ACCESSIBILITY ASSESSMENT

ADA TITLE II ASSESSMENT

Abernethy Hall
131 South Columbia Street
Chapel Hill, North Carolina 27514

July 22, 2024

Map for Barrier ID: AX456002

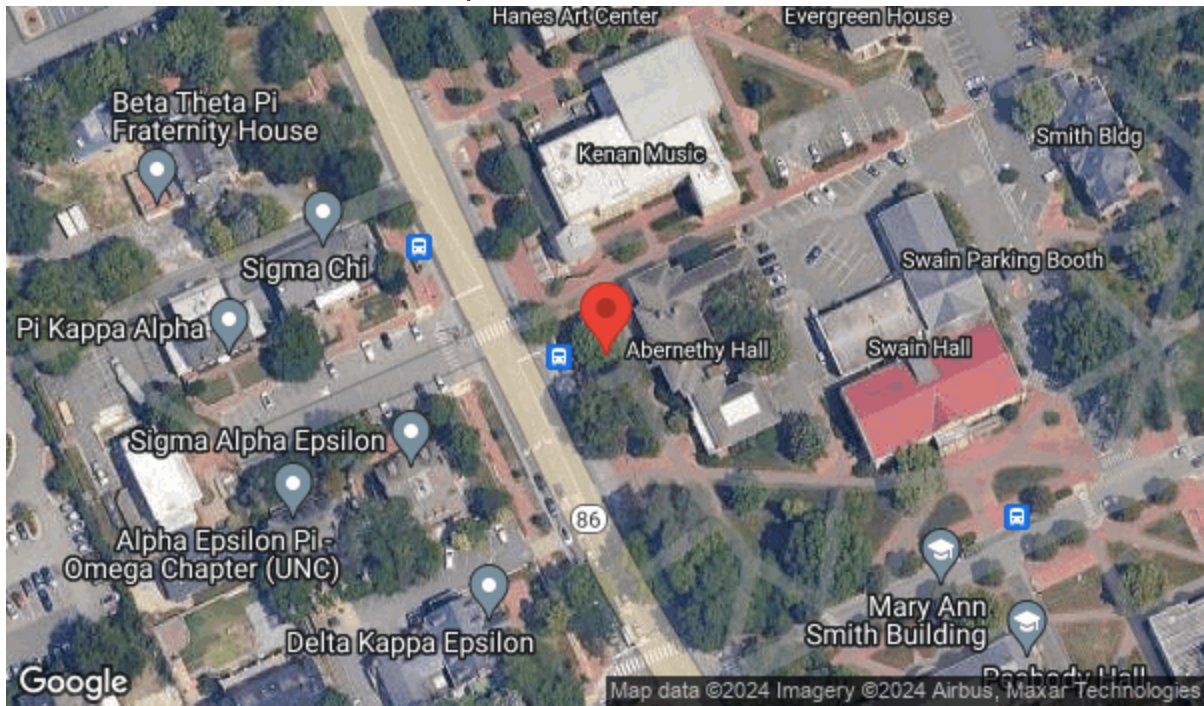
Assembly	Exterior Access Route	
Type	Reach Range	
ADA Standard	308, 309	
Barrier Detail		
Items requiring an obstructed forward reach motion are higher than 48" maximum height where the depth of the obstruction is 20" maximum, or greater than 44" maximum height where the depth of the obstruction is 20" to 25" maximum, or lower than minimum 15" height above finish floor.		
Location Description	Emergency Call #94	
Observed	May 20, 2024 by Brian.rogers@bureauveritas.com	
Site Conditions	The call button for the Emergency Call #94 is 51" above the ground.	
Height	51"	
Resolution		
Relocate part to a compliant reach range. Where a forward reach is unobstructed, the high forward reach shall be 48" maximum and the low forward reach shall be 15" minimum above the finish floor or ground. the element for a distance not less than the required reach depth over the obstruction. The high forward reach shall be 48" maximum where the reach depth is 20" maximum. Where the reach depth exceeds 20", the high forward reach shall be 44" maximum and the reach depth shall be 25" maximum. [EXCEPTION: An obstruction shall be permitted between the clear floor or ground space and the element where the depth of the obstruction is 10" maximum.] [ADVISORY for Children's Forward or Side Reach Ranges: High reach (maximum): 36" for ages 3 to 4; 40" for ages 5 to 8; and 44" for ages 9 to 12. Low reach (minimum): 20" for ages 3 to 4; 18" for ages 5 to 8; and 16" for ages 9 to 12.]

Map for Barrier ID: AX456001

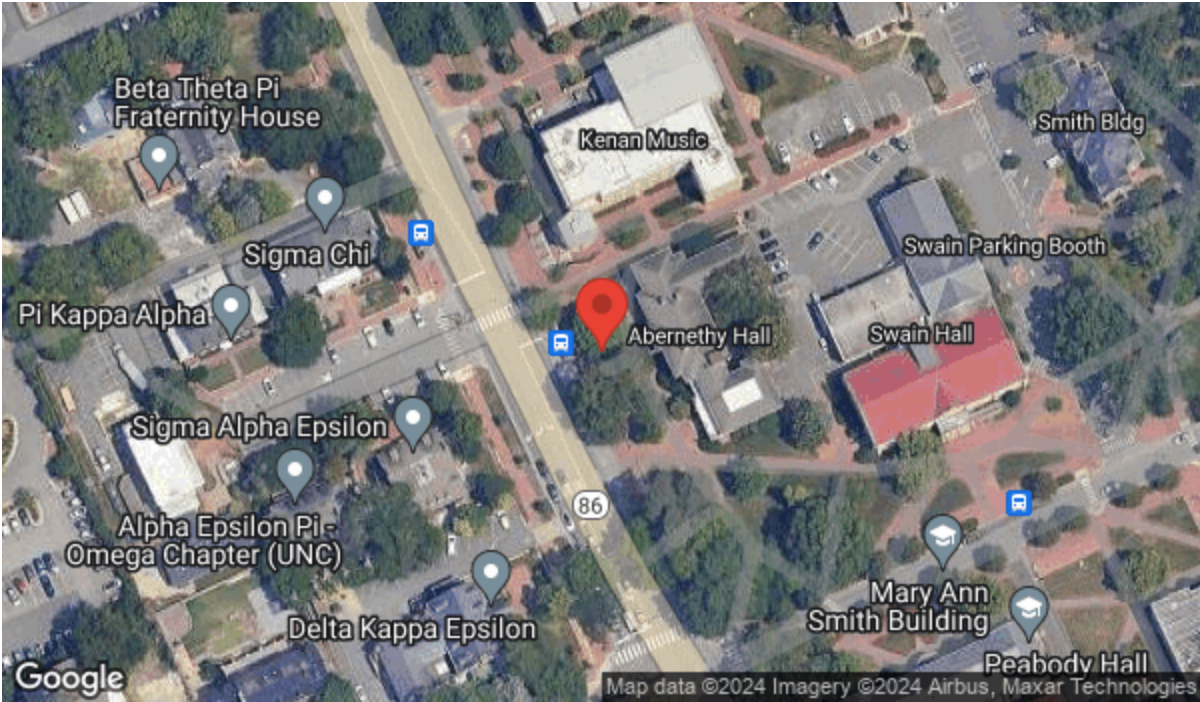
Assembly	Exterior Access Route
Type	Clear Space
ADA Standard	305; 309.2
Barrier Detail	Clear space is not provided at the operable part.
Location Description	Emergency Call #94
Observed	May 20, 2024 by Brian.rogers@bureauveritas.com
Site Conditions	Emergency Call Station #94 is 21 inches from the brick walkway.
Length	21"

Provide clear space at the operable part. Floor or ground surfaces of a clear floor or ground space shall have slopes not steeper than 1:48, and shall be stable, firm, and slip resistant. Clear space shall be 30" minimum by 48" minimum, positioned for a forward or parallel approach. One full unobstructed side shall adjoin an accessible route or adjoin another clear floor or ground space. Clear floor or ground space shall include knee and toe clearance.
